Resettlement Action Plan

Justification Note for Corridor 2 Resettlement (Kanpur Metro Rail Project)

(May 2025)

Uttar Pradesh Metro Rail Corporation

CSA Metro Station (Revised)

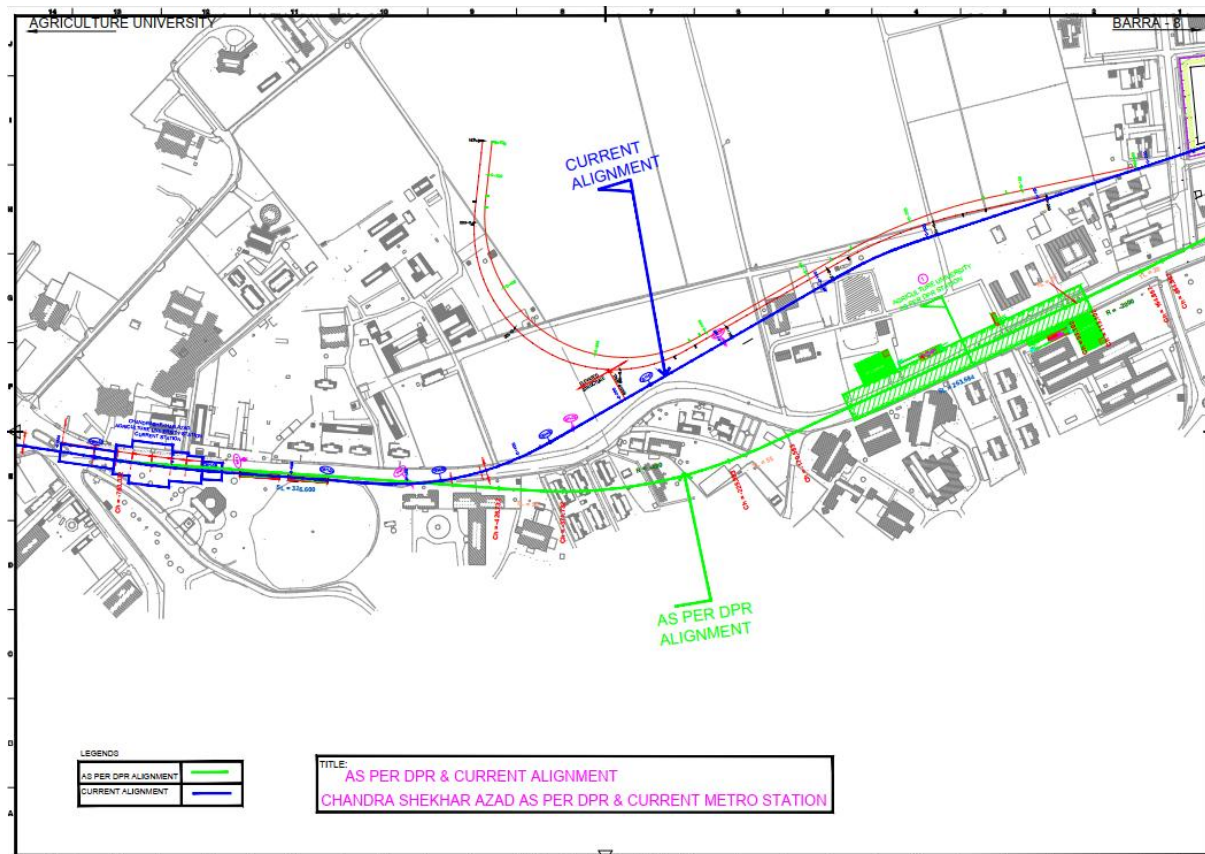
Originally designed as an underground station, this metro stop was later reconfigured as an elevated station to accommodate potential future expansion in adjacent areas. The DPR had estimated that three structures, classified under the “others” category, might be affected during the construction of the underground station.

However, with the change to an elevated design and relocation of the station, all these structures remained unaffected.

Kakadeo Metro Station (Revised)

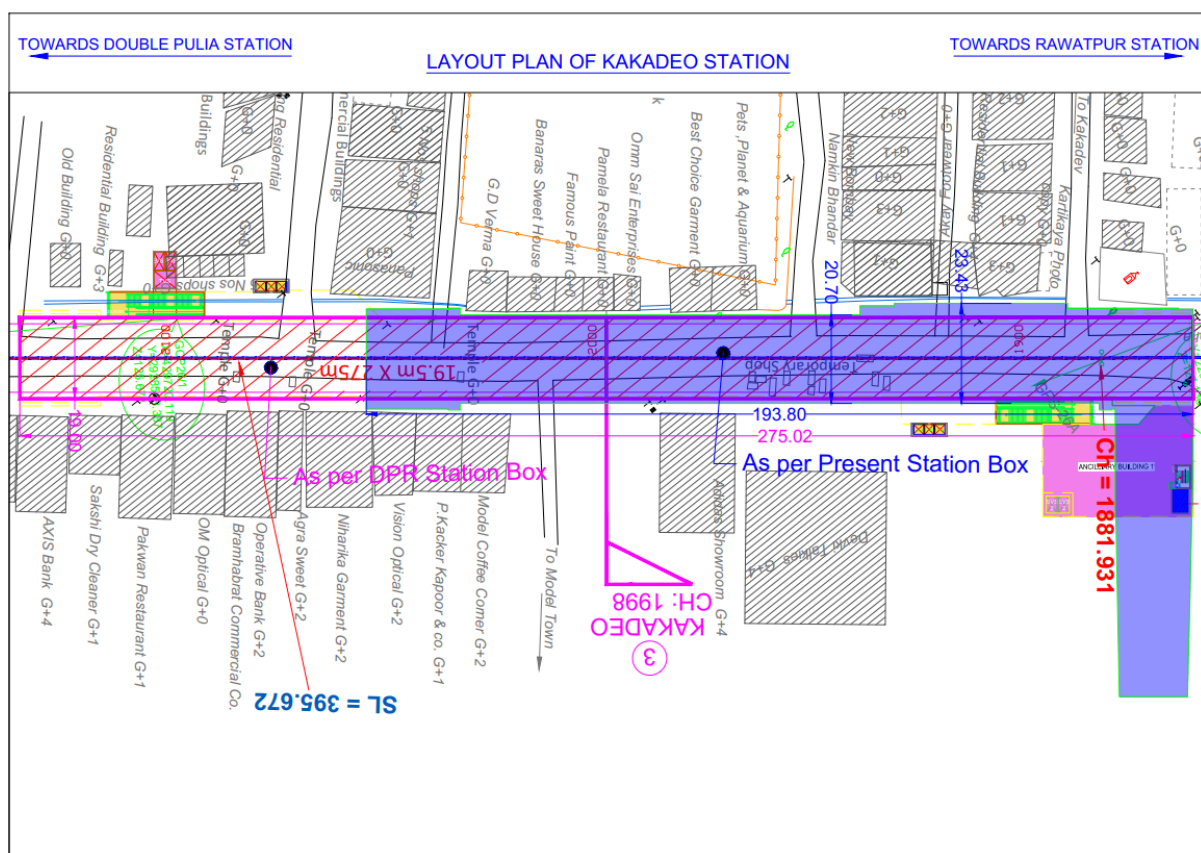
Initially planned as an underground station with a length of approximately **260 meters**, the Kakadeo Metro Station was expected to impact **nine structures**, as per the DPR. However, **design optimization** resulted in a **reduced station length of 192 meters & width of 20meters**, significantly minimizing its footprint.

By repositioning the metro station within an available land pocket ie on available right of way of road & locating the entry exits at locations where vacant spaces are available, the project successfully eliminated any impact on existing structures.

Double Pulia Metro Station (Revised)

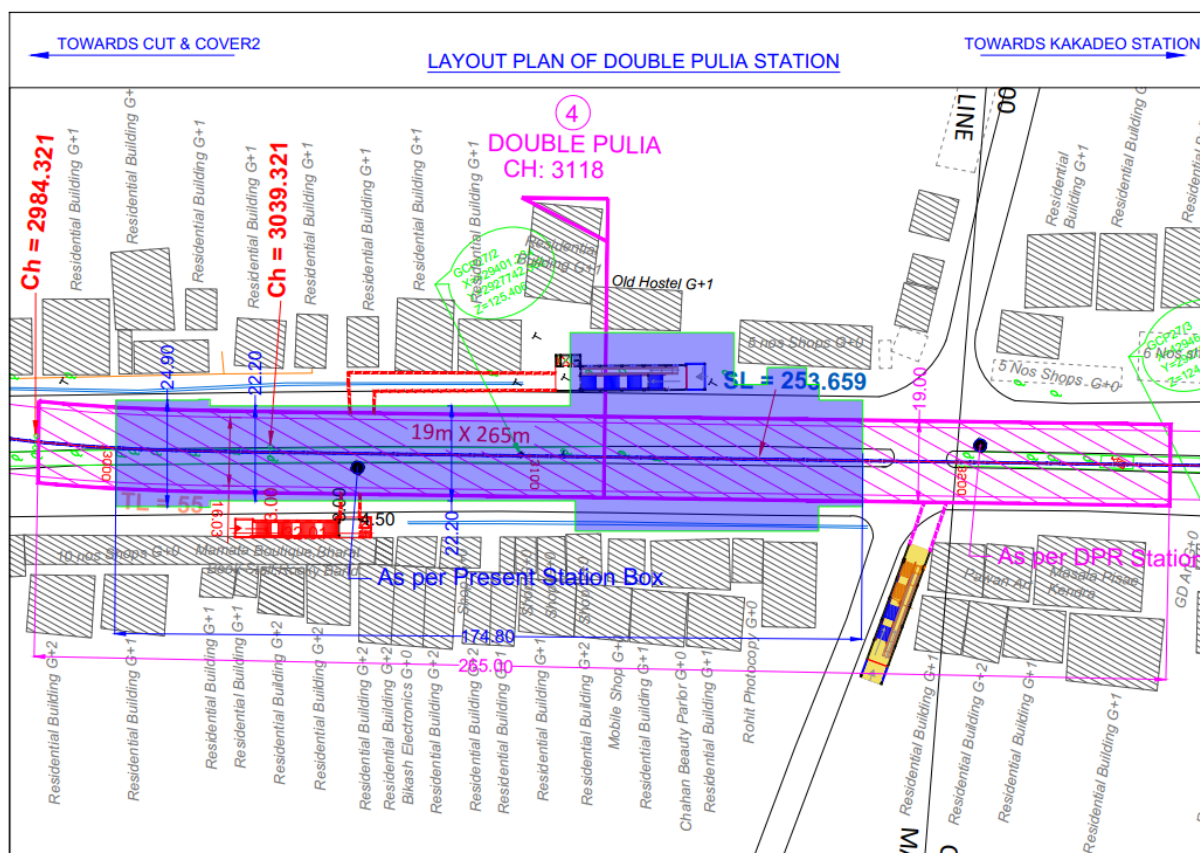
Initially planned as an underground station with a length of approximately 260 meters, the Double Pulia Metro Station was expected to impact 13 structures, as per the DPR. However, through design optimization, the station length was reduced to 174 meters and 20mtr width, significantly minimizing its footprint.

By repositioning the metro station within an available land pocket ie on available right of way of road & locating the entry exits at locations where vacant spaces are available, the project successfully eliminated any impact on existing structures.

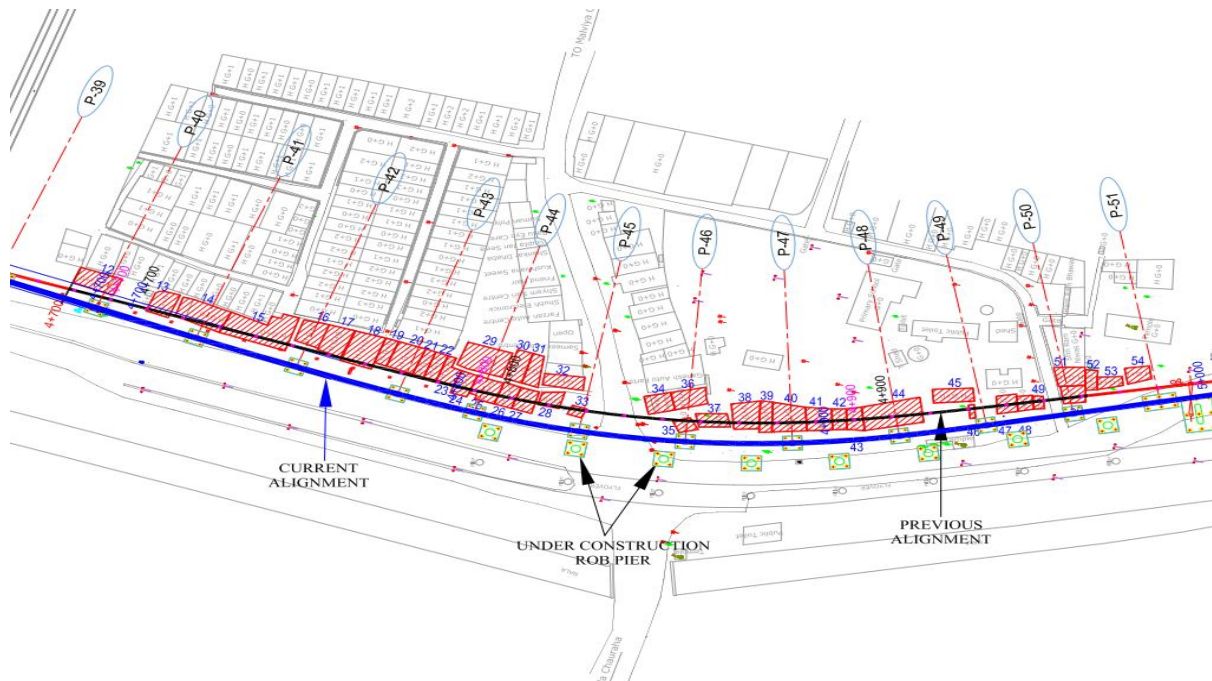
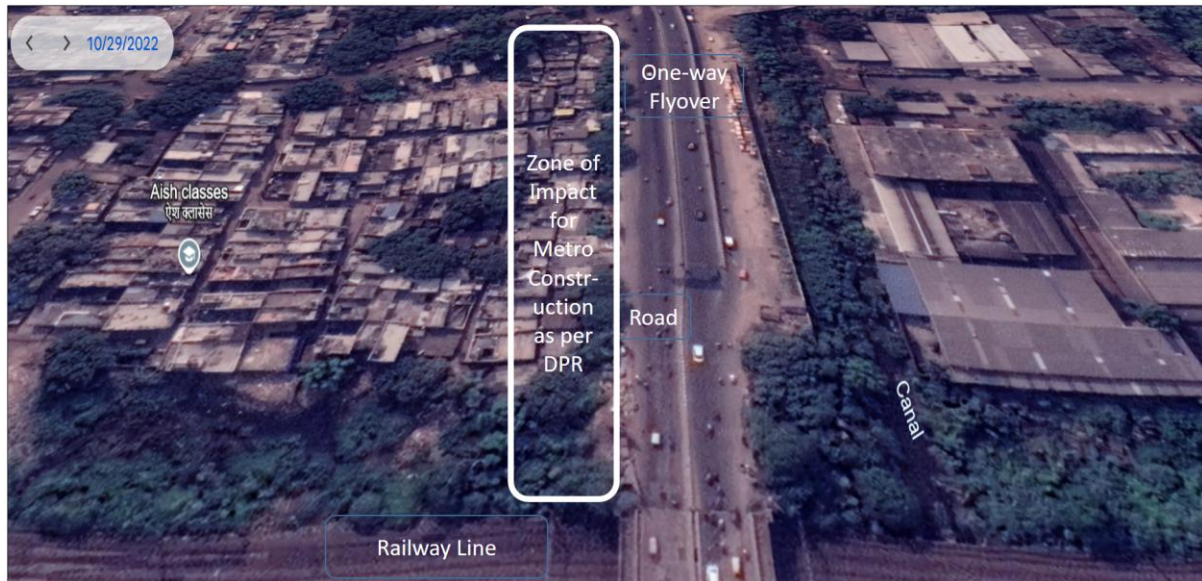
Originally, the DPR for Corridor 2 showed the metro alignment passing through a parcel of government land occupied by non-titleholders. This would have required the resettlement of these 184 structures. The land initially identified for the construction of the metro viaduct was later required by the Bridge Corporation for a separate infrastructure initiative. Following technical coordination with the Bridge Corporation, UPMRC adjusted the metro alignment by shifting it 7.29 meters closer to the new flyover to be constructed by the Bridge Corporation. This optimized the UPMRC route and fully avoided the previously identified resettlement impact. In 2023, the Bridge Corporation began constructing the new flyover in the same area—an entirely separate state project. To accommodate the flyover and an adjacent slip road, the Bridge Corporation cleared the encroachments on that land, levelling the affected structures as part of their own project. The 184 structures (PAHs) initially identified for resettlement in Vijay Nagar under the Kanpur Metro Project's Corridor 2 were moved by Bridge corporation.

As shown in the drawing below, the black line represents the alignment according to the DPR, with potentially affected structures marked in red.

In 2023, the Bridge Corporation decided to construct a second flyover next to the existing one. This new flyover is also designed to be 10 meters wide, with a 2-meter gap between the two structures. As a result, the entire road and adjacent unpaved area would be utilized for the new flyover. To maintain traffic flow during construction, a service road became essential. For this purpose—and to provide working space for the construction agency—the nearby government land, which had been occupied by squatters, was cleared by Bridge Corporation with the help of land owning government department and district administration.

was mutually agreed to shift the metro alignment closer to the upcoming flyover to ensure a clear Right of Way (ROW) for future developments. It was also decided to elevate the metro corridor to avoid any interference with the flyover structure.

Image: Vijay Nagar Viaduct Area – revised

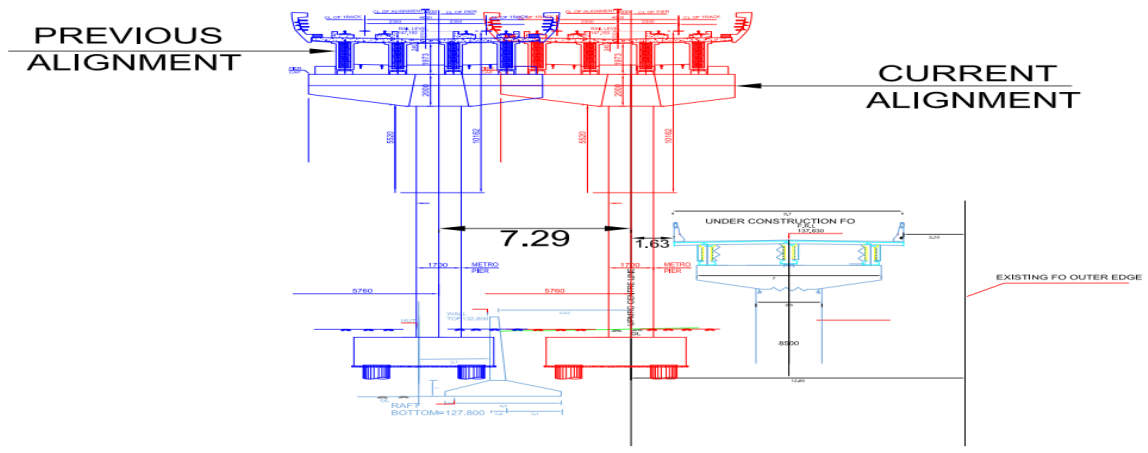
The images below show the same location, taken two years apart. The first image, dated August 2022, clearly shows an adjacent road to the flyover and the presence of squatters and encroachments in the nearby low-lying area. To facilitate the construction of the new flyover, Bridge Corporation cleared approximately 10 meters of land on the left side, removing squatters and encroachers from government-owned land. This clearance was carried out well in advance of the commencement of metro construction activities in the area. As a result, no Rehabilitation and Resettlement (R&R) activities were required or undertaken in this zone by Kanpur Metro Project.

Govind Nagar Metro Station

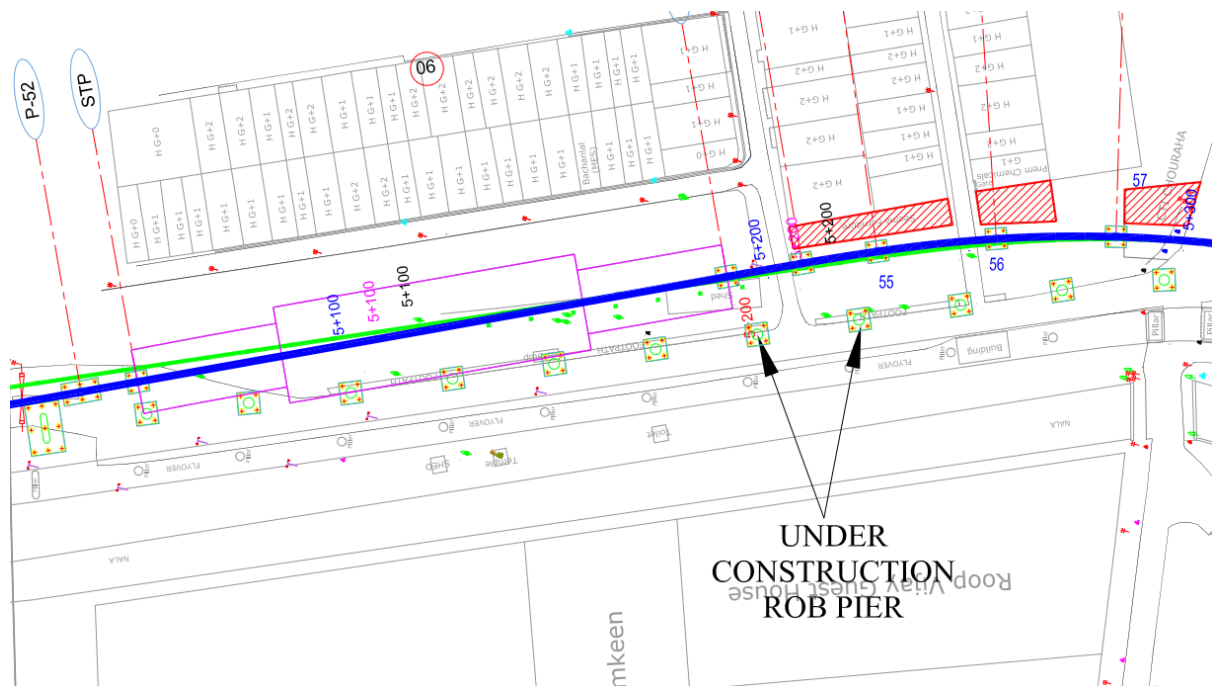
However, due to modifications in the alignment, all eight structures remain unaffected. Additionally, the alignment has been shifted to the right, effectively avoiding the need for any structural dismantling.

The following drawings illustrate these changes. Blue coloured line refers to current alignment while the green line refers to DPR alignment:

Shastri Nagar Metro Station

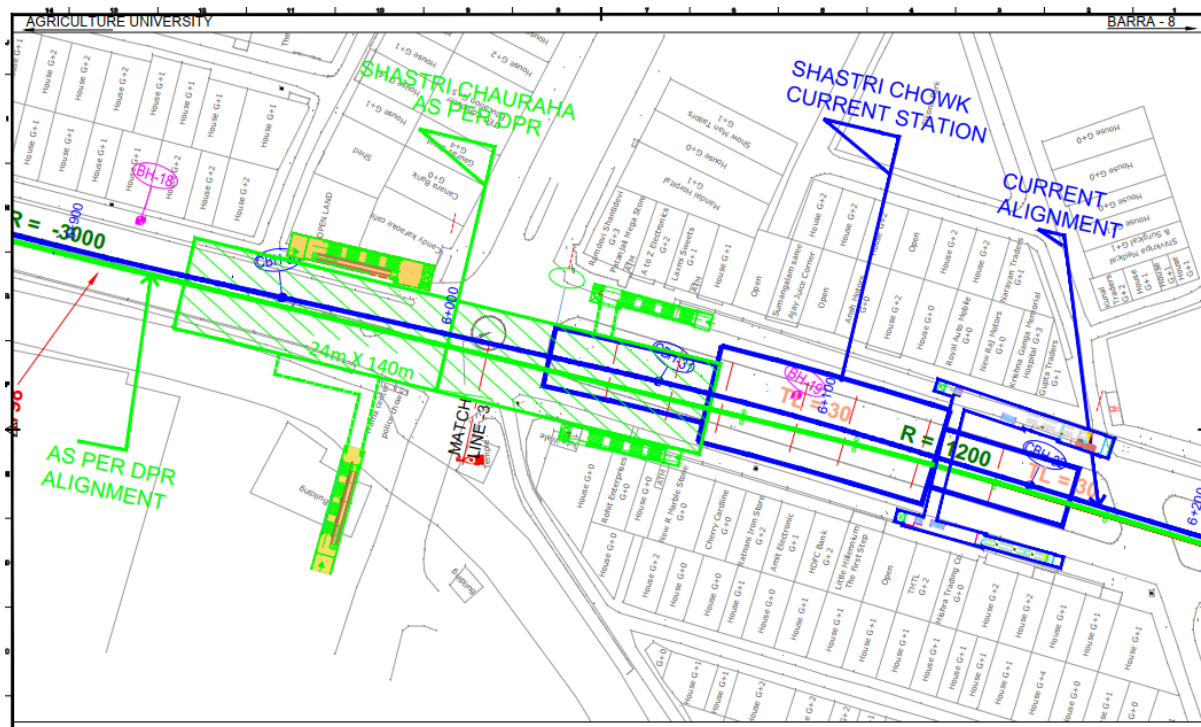
However, due to **modifications in the station's design and location**, all **five structures remain unaffected**. Additionally, the **station length has been adjusted to 60mtrs**, and the **alignment has been shifted to the right**, effectively preventing the need for any structural dismantling.
